# Effect of pattern on Vdiffptp

(in support of comment 37)

Adee Ran, Cisco

Cl 120G SC 120G.5.1 P 264 L 31 # 37

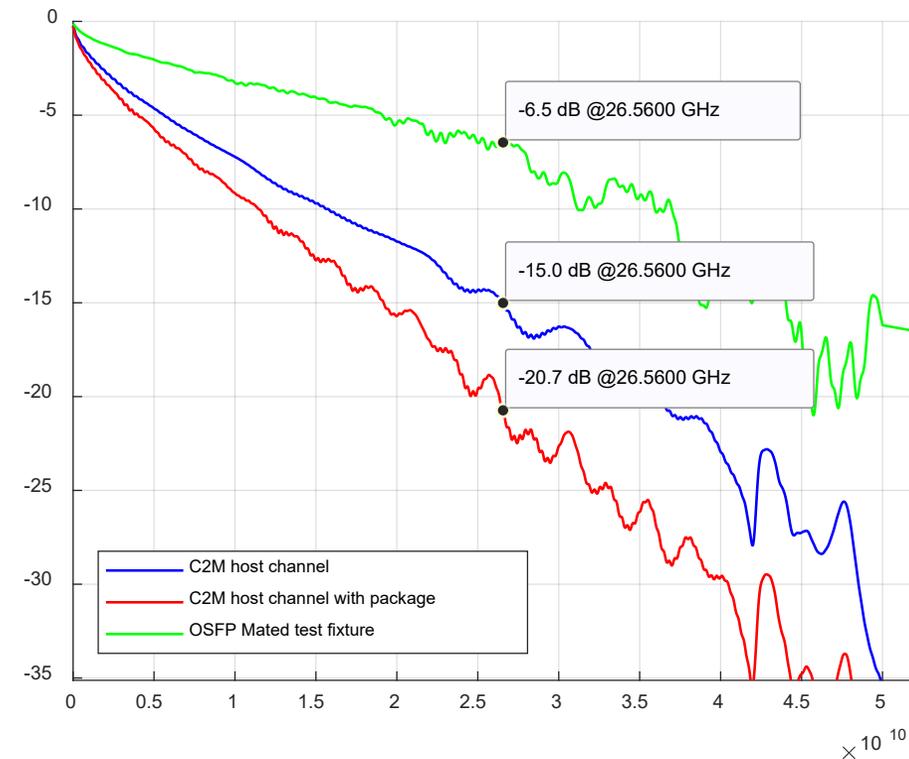
This clause is referred to in Table 120G-1 and Table 120G-3 for the parameter differential PtP output voltage (max), among others.

The content is only a reference back to 120E.3.1.2: "The signal levels are as defined in 120E.3.1.2". 120E.3.1.2 does have a definition of differential signal but also states that "Unless otherwise noted, differential and common-mode signal voltages are measured with a PRBS13Q test pattern".

But PRBS13Q is not an appropriate signal for measurement of the PtP output voltage, because it has a maximum run length of 7 symbols and does not have any spectral content below 3 MHz. Much longer runs are possible in real data. Measurement with PRBS13Q over a lossy channel between the transmitter and the measurement point, without sufficient equalization, can thus yield peak-to-peak value lower than the value that real data would create.

Since there is no way to control the transmitter's swing or equalization, this may cause events of higher signal levels than the receiver expects, and cause periods of high BER, which can span many FEC symbols and cause uncorrectable codewords.

It is proposed to define the differential PtP explicitly as a requirement for any data pattern, and recommend to measure it using a pattern that contains low-frequency content, such as PRBS31Q or SSPRQ.

Replace the content of 120G.5.1 with the following:

"The definition of differential and common-mode signals can be found in 120E.3.1.2. The signal levels specifications for host and module outputs hold for any data pattern. It is recommended to measure differential peak to peak signal levels with PRBS31Q or SSPRQ test pattern."

Consider applying similar changes in 162, 163, and 120F, with editorial license.

# PRBS13Q

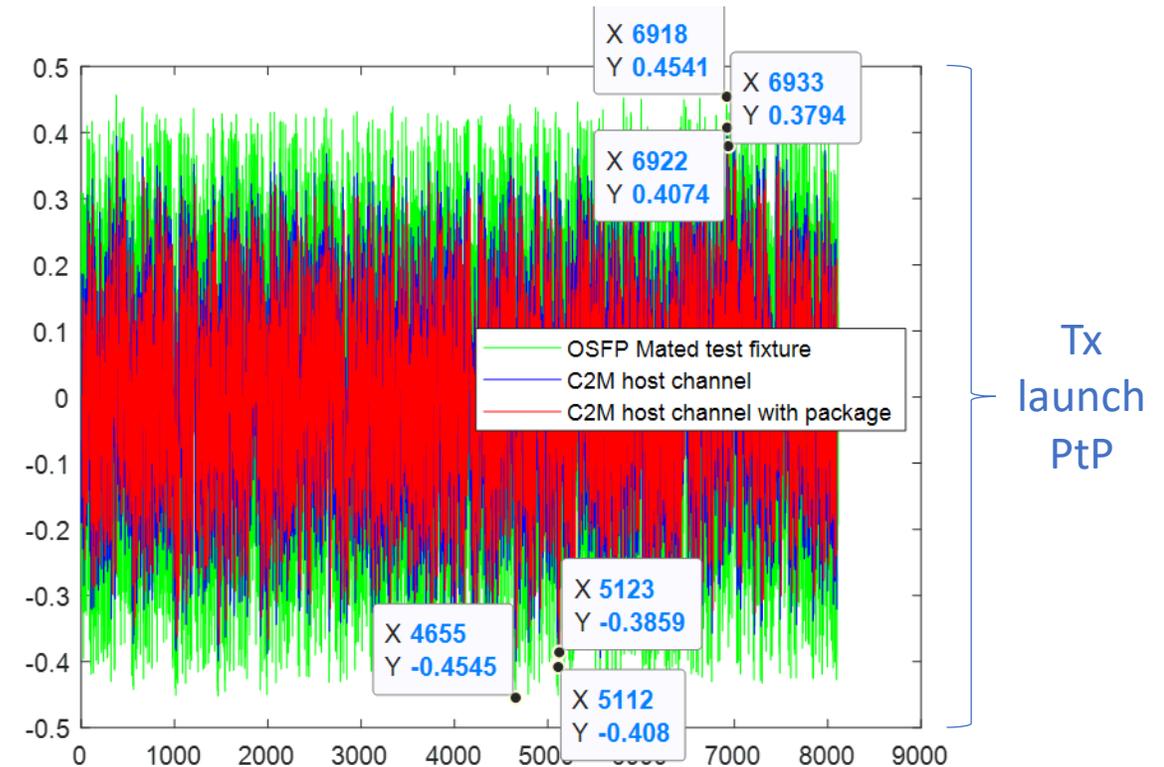
Measurement with PRBS13Q is much lower than the launch PtP and is channel dependent.  
With scrambled data the signal can reach the launch voltage.  
The dynamic range that the receiver will need to handle can't be deduced from the measurement.

# SSPRQ

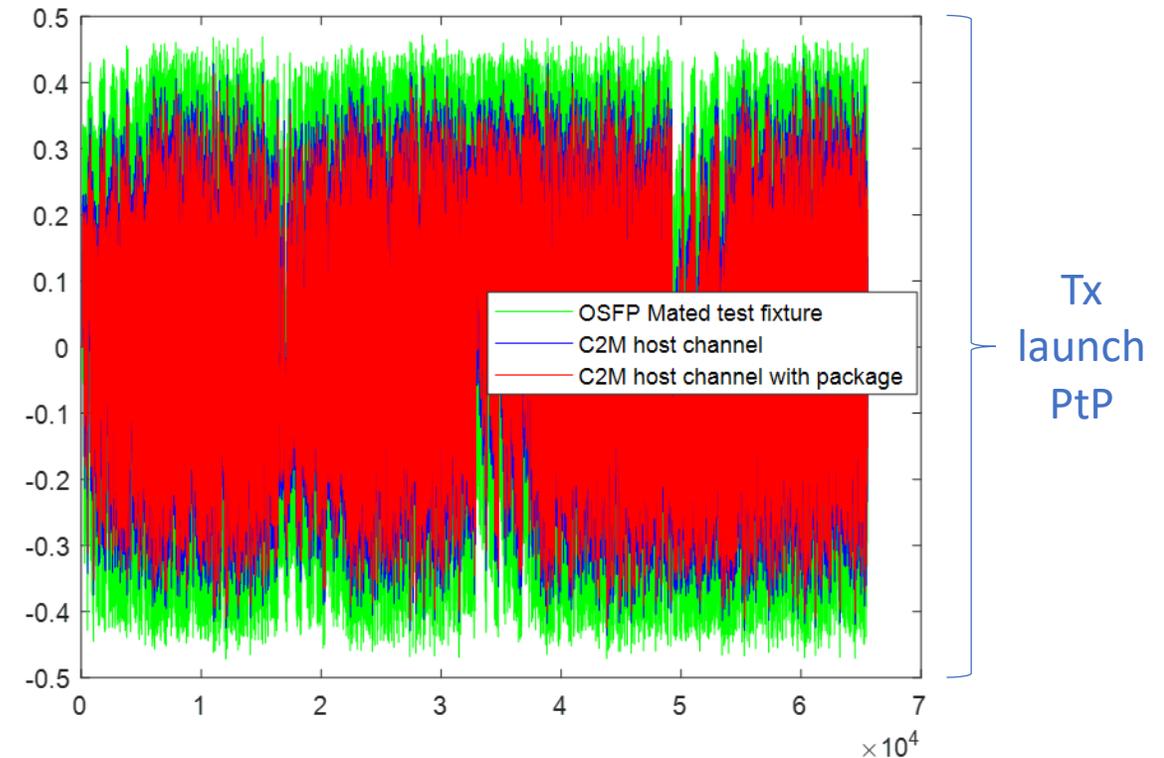
Measurement with PRBS31Q or SSPRQ is still lower than the real PtP that the signal may reach. But the channel dependence is smaller.

# Comparison of SSPRQ and PRBS13Q with different Tx equalization

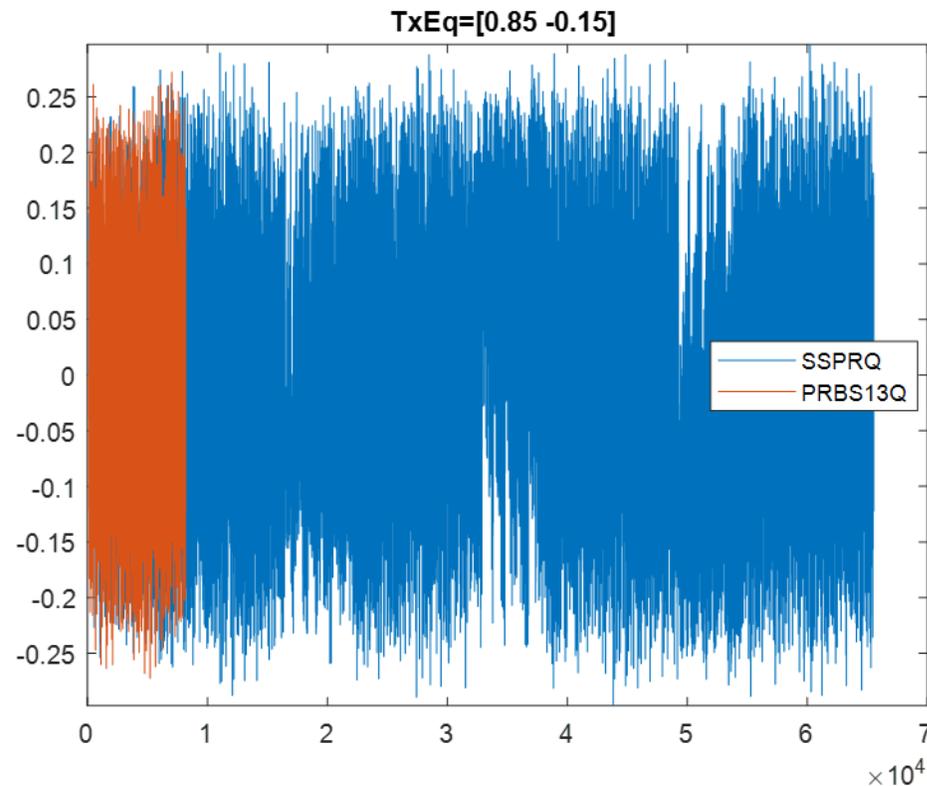
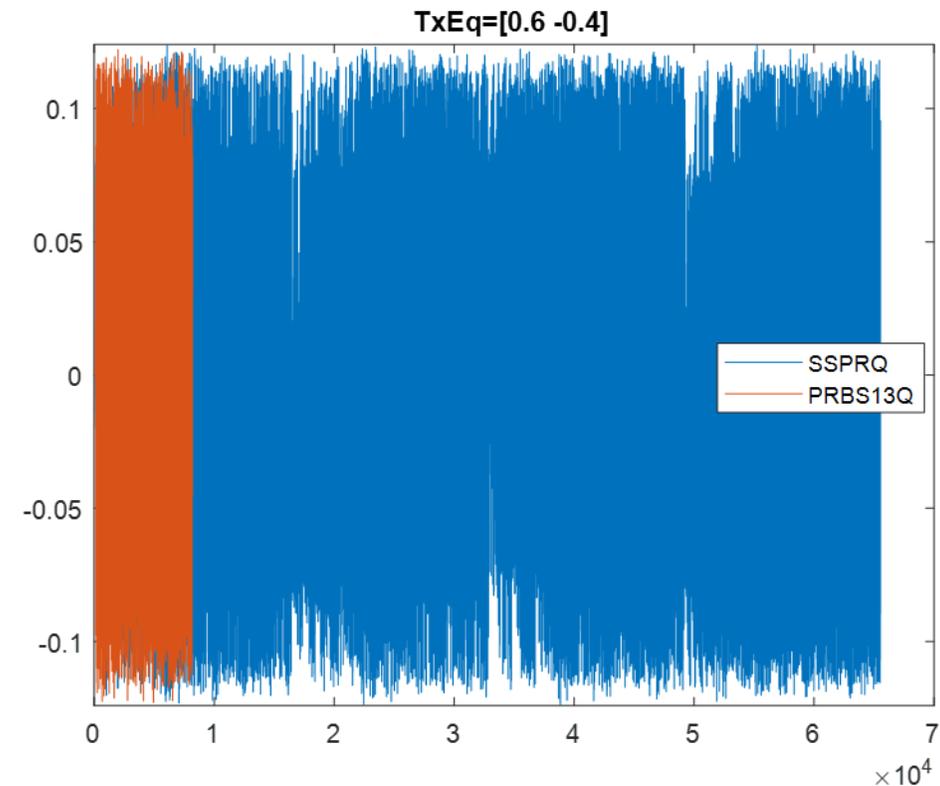
Mild Tx equalization (reasonable)

Strong Tx equalization (not expected)
